**RE: Technical Revision 07- Holton Mine (Permit M-2008-082) Adequacy Review Response**

This letter is in response to the Technical Revision 07 (TR07) – Adequacy Review letter from the Division dated December 2, 2020. I have copied your requests below and have responded to each in red. I have also included a spreadsheet with the requested reclamation costs broken out per pond to help with your review(Attachment A). The costs are based on a competitive bid process completed in the Fall of 2020.

# Figure 1

Updated Mine and Reclamation Plan

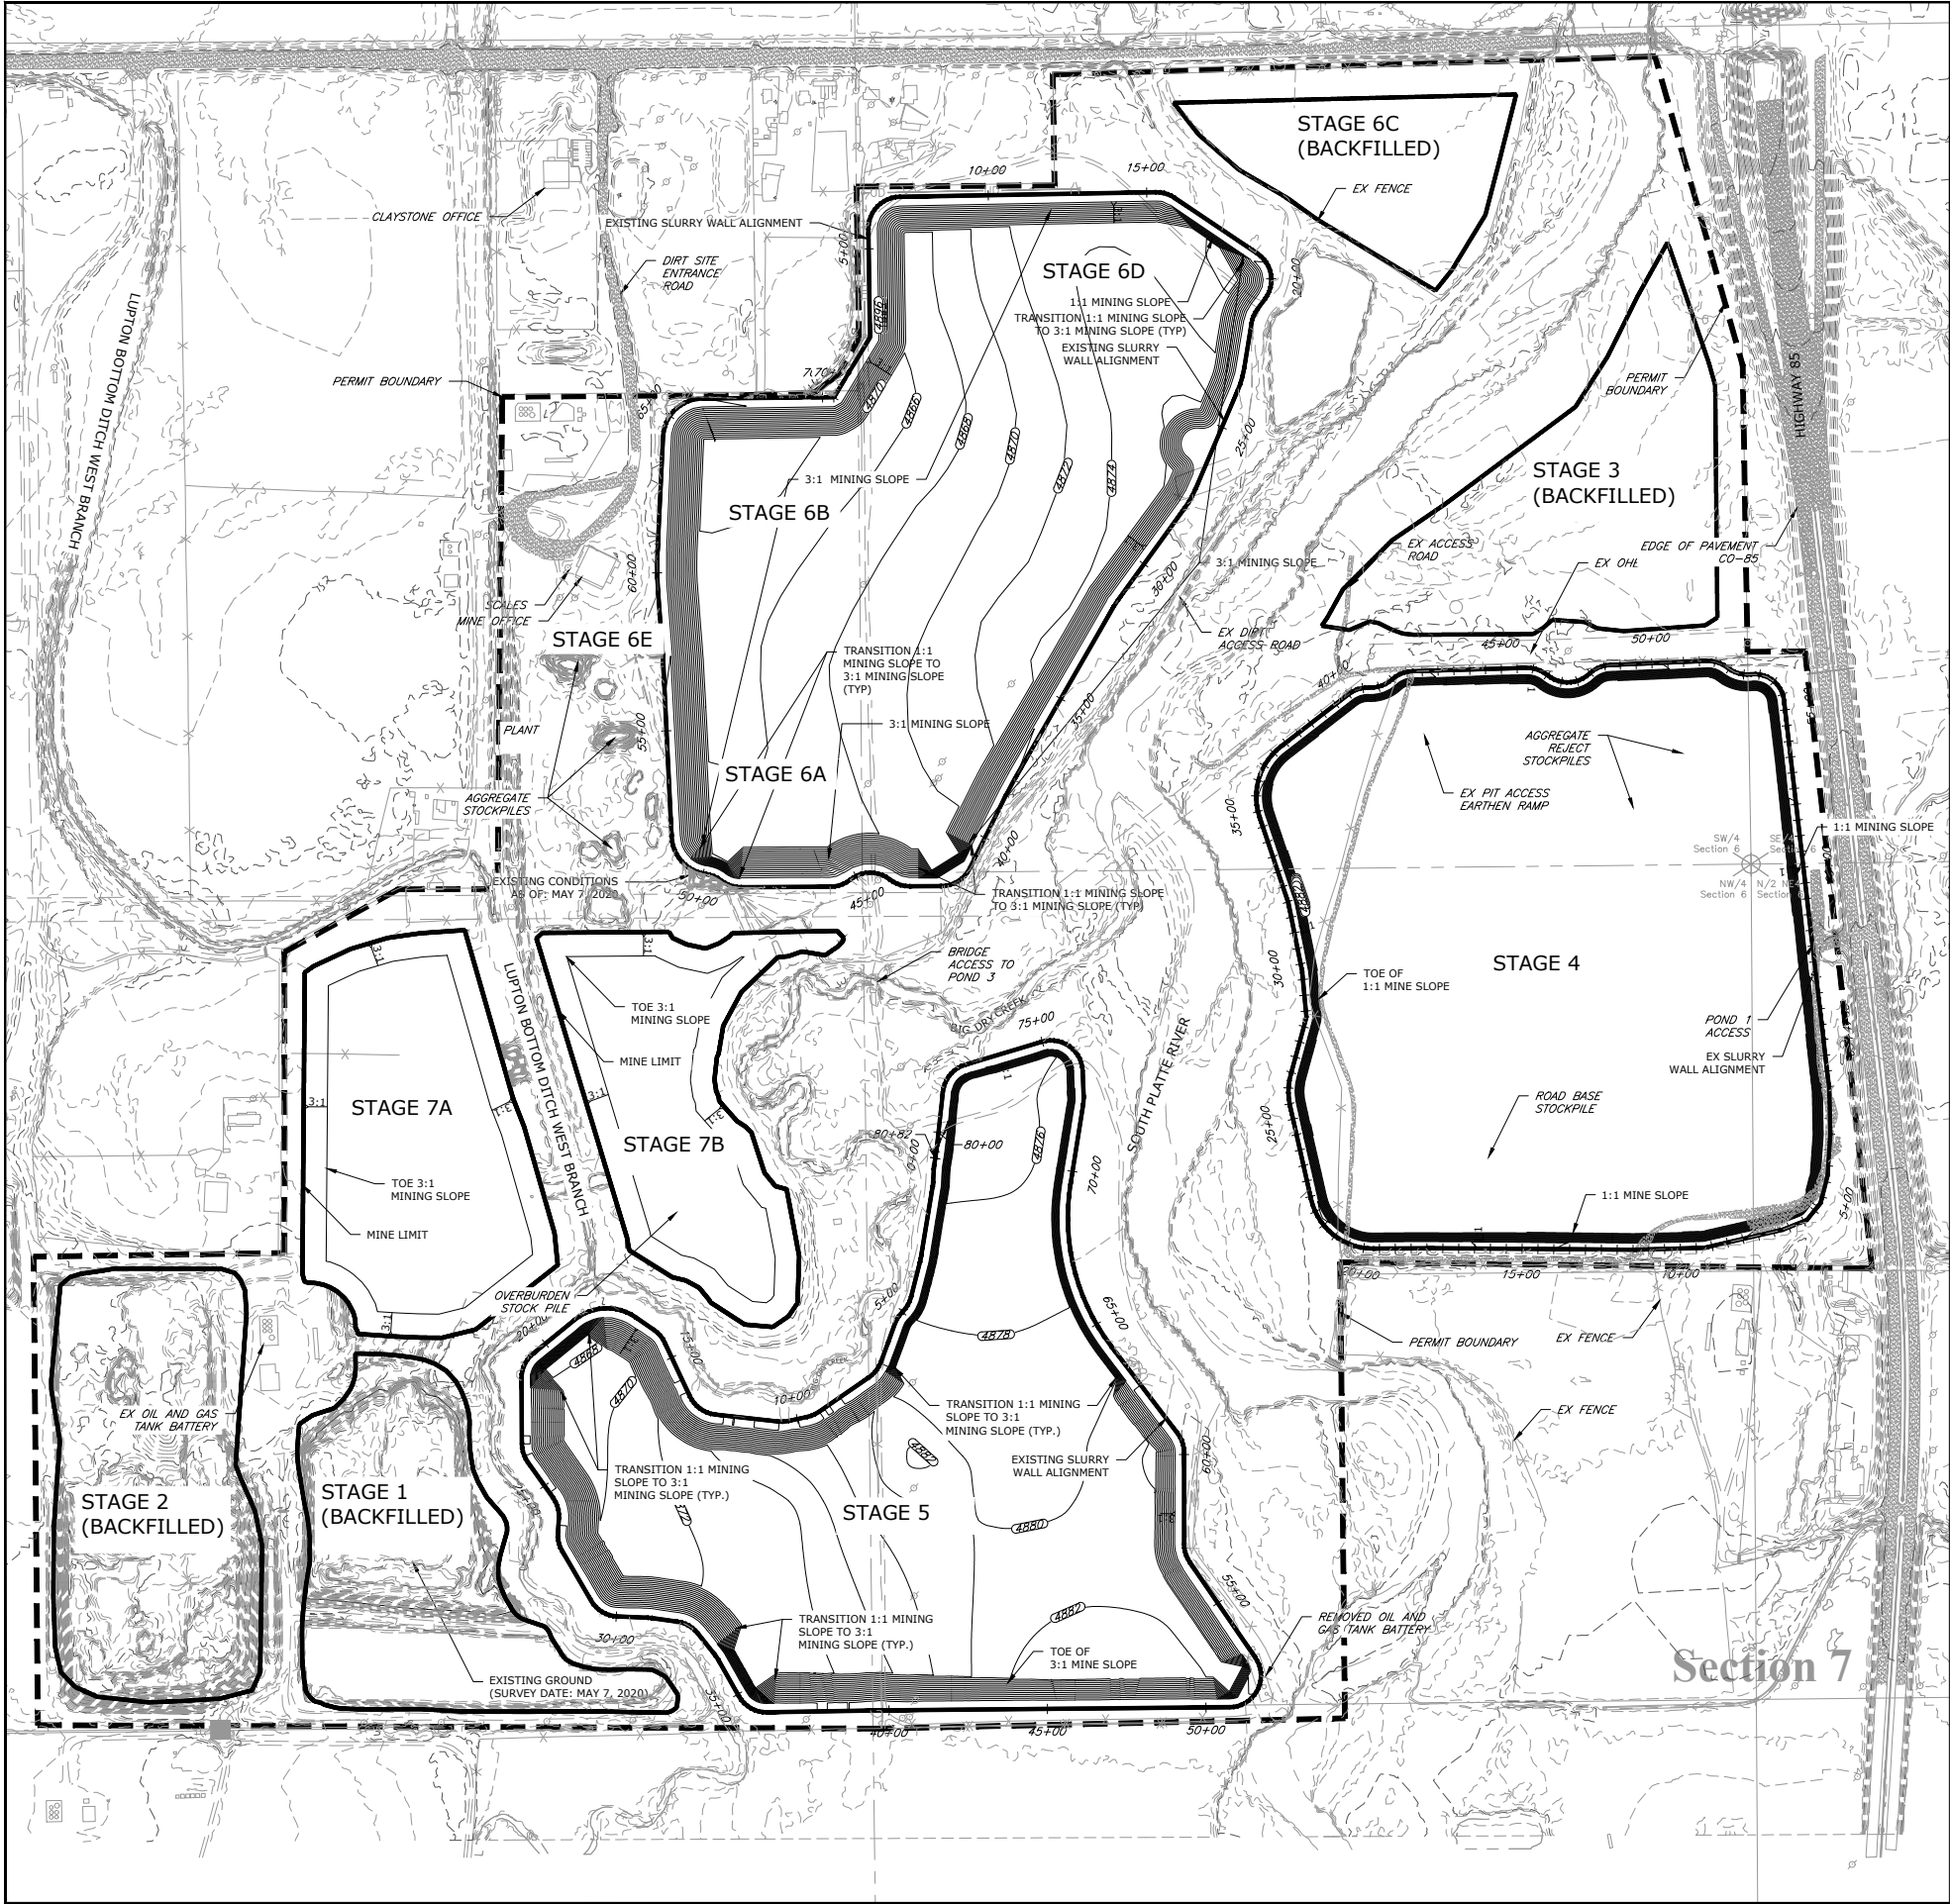
- 5) Please modify the provided maps to make sure that all areas to be reinforced with compacted clay and/or modified from 3:1 interior slopes to 4:1 interior slopes for Ponds 1-3 are clearly and accurately depicted. **The Mining Plan Map and the Reclamation Plan Map have been updated to call out locations where compacted clay and 4:1 slopes are located.**

- 7) Please correct the permit boundary in the NW corner of the permit on the maps provided to match the approved permit boundary as approved in AM01. **The permit boundary has been updated as requested.**
